CITY OF ALBUQUERQUE

Re: 7-Brews Coffee
4331 Wyoming Blvd. NE
30-Day Temporary Certificate of Occupancy
Transportation Development Final Inspection
Architect's Stamp dated 04-19-23 (G19-D004F)
Certification dated 06-17-24

TRAFFIC CERTIFICATION

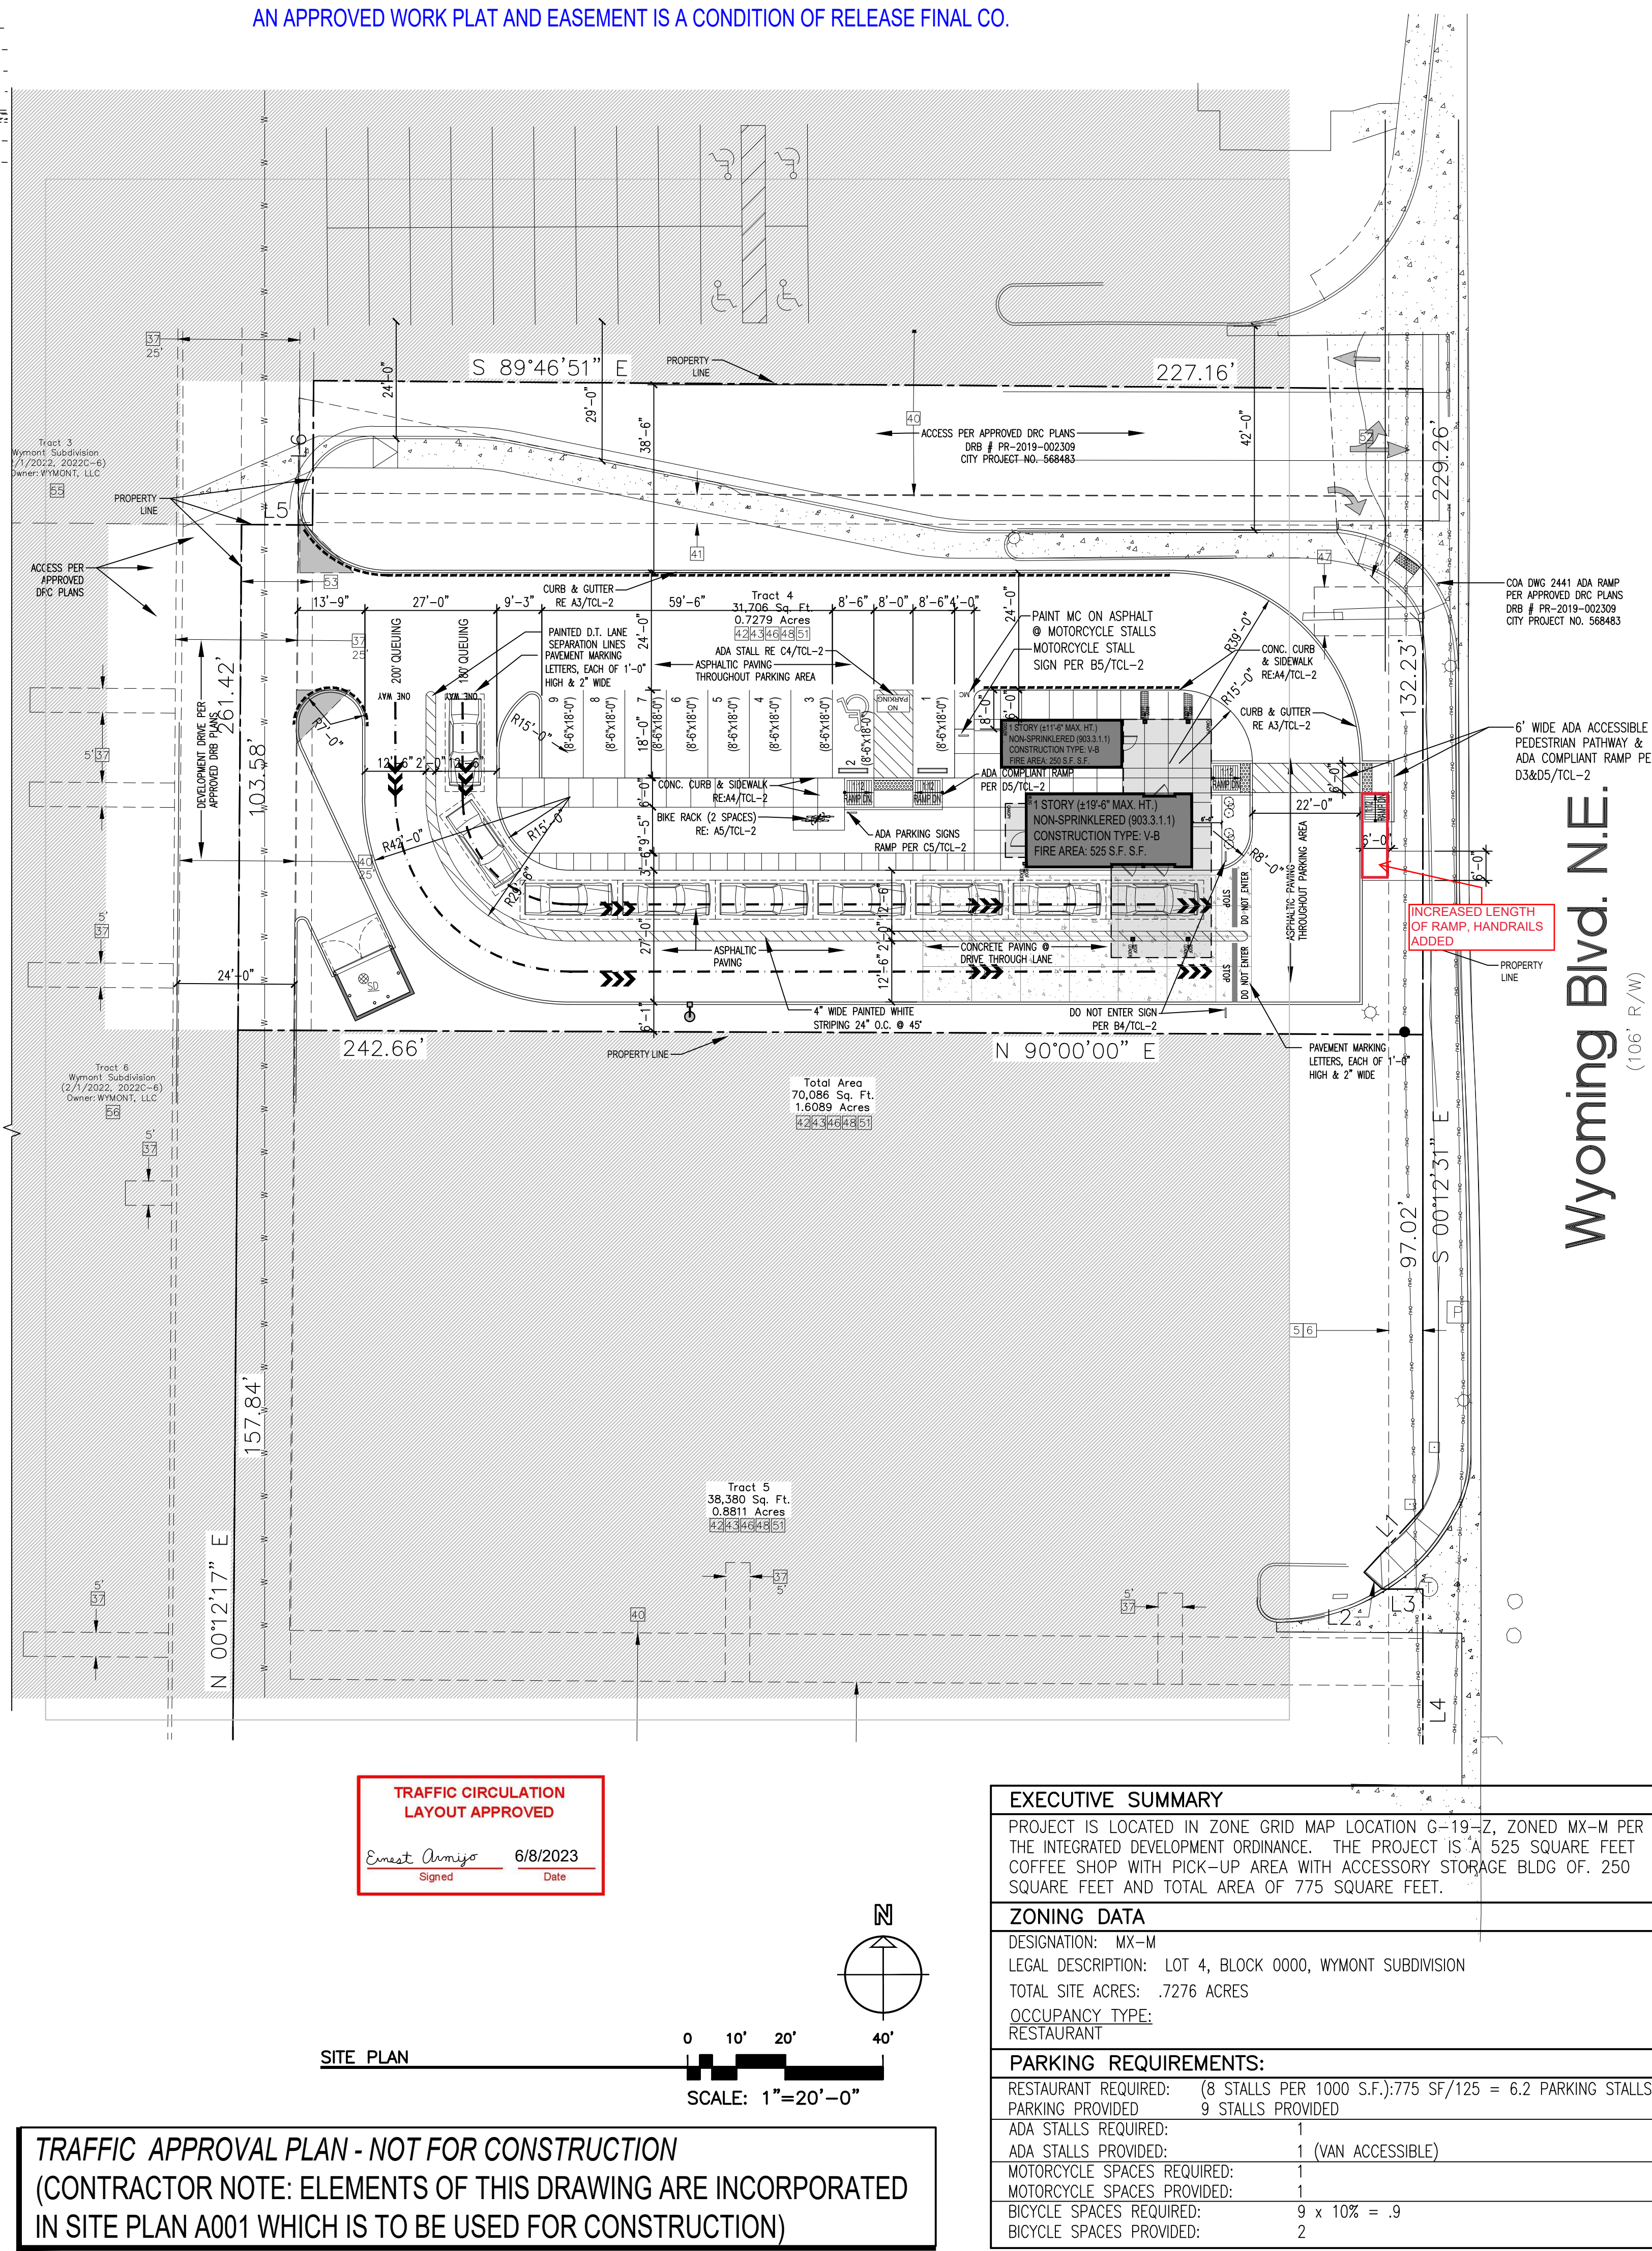
- The minimum ADA parking space width should be 8.5 ft. However, per site visit it was only 8 ft. wide. Please provide an 8.5 ft. wide ADA parking space.
